**RE: 833 South 800 East Rezone and Master Plan Amendment
PLNPCM2019-01111**

**RE: 833 South 800 East Rezone and Master Plan Amendment
PLNPCM2019-01111**

Re: PLNPCM2019-01110 – Master Plan Amendment
PLNPCM2019-01111 – Zoning Map Amendment
PLNSUB2019-01112 – Telegraph Exchange Lofts Planned Development

AS1-01

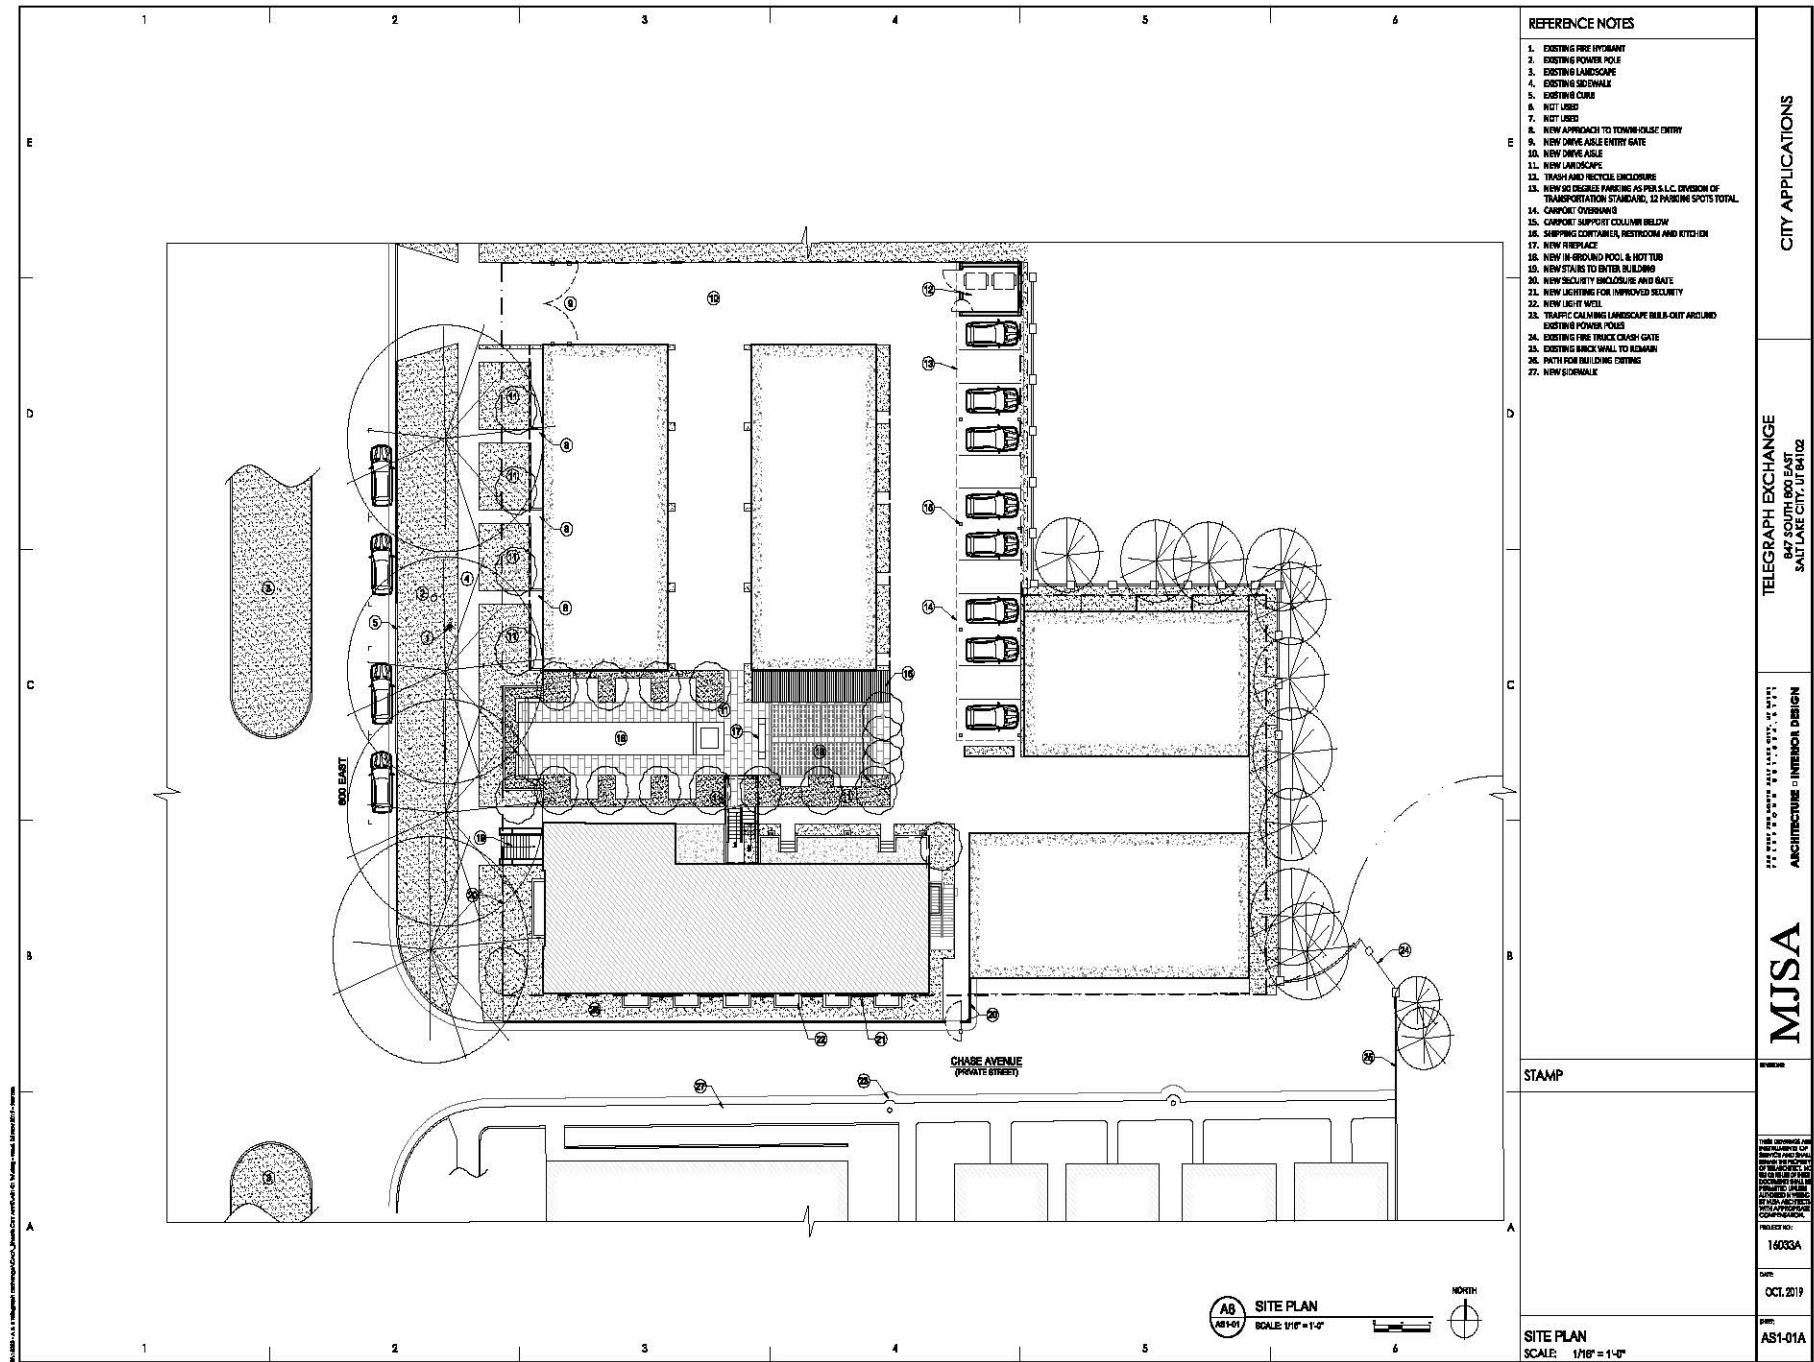
The Architectural Site Plan, sheet AS1-01, shows new sidewalk to be installed on the south side of Chase Avenue. SLC Engineering has no objection to this but since Chase Avenue is a private street, consent of the property owners who have rights to Chase Avenue must be obtained prior to installation of the sidewalk.
